UNITED STATES PATENT AND TRADEMARK OFFICE

Office Action Summary	Application No. 10/814,597	Applicant(s) LEON ET AL.	
	Examiner Jeffrey Sharp	Art Unit 3677

DETAILED ACTION

Higdon et al. US-6,004,065

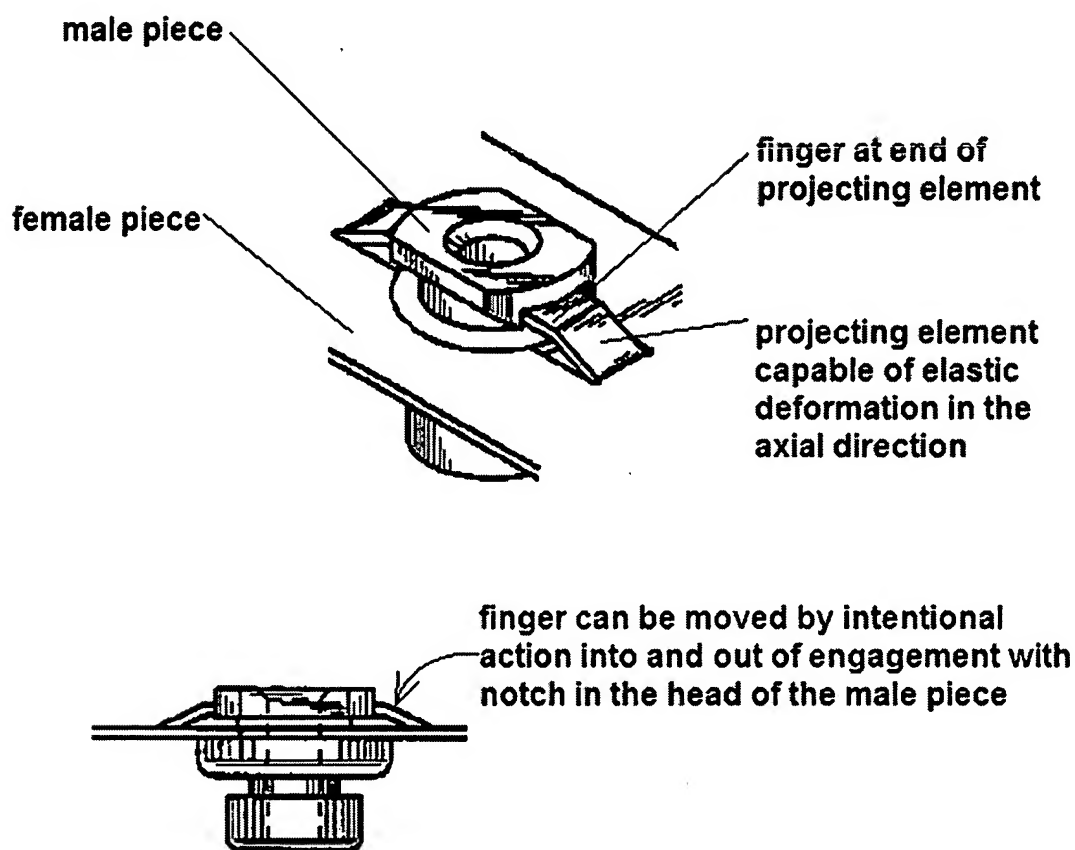
Higdon et al. suggest a fastening device having an anti-rotational component (70) projecting from a female piece (30) and into/out of engagement with a notch (68) formed in a male piece (50), said component (70) comprising *resilient, axially deflectable projections and fingers at each of their free ends*. The fingers (70) are deflectable in an axial direction with respect to the shaft (54,60) axis of the male piece (50), and engage a notch (68) in the head (52) of the male piece (50), so as to prevent accidental rotation of the male piece (50) within the female piece (30). Accidental rotation of the male piece (50) is undesirable (as stated by Applicant in vibration environments), because it threatens the "holding together a stack of panels". In order to achieve an *unlocked* position (i.e., position which allows rotation of the male piece (50) within the female piece 30), the fingers (70) are axially deflected in between the two head portions (52, 56) and out of the notch (68) of the head (52) of the male piece (50). This is facilitated by cutouts (66), as Higdon et al. specifically disclose that clearance flats (i.e.,

"cutouts") are necessary for the first head portion (52) to clear the fingers (70) upon axial insertion of the male piece (50) into the female piece (30). See Higdon et al. Col 3 lines 26-38.
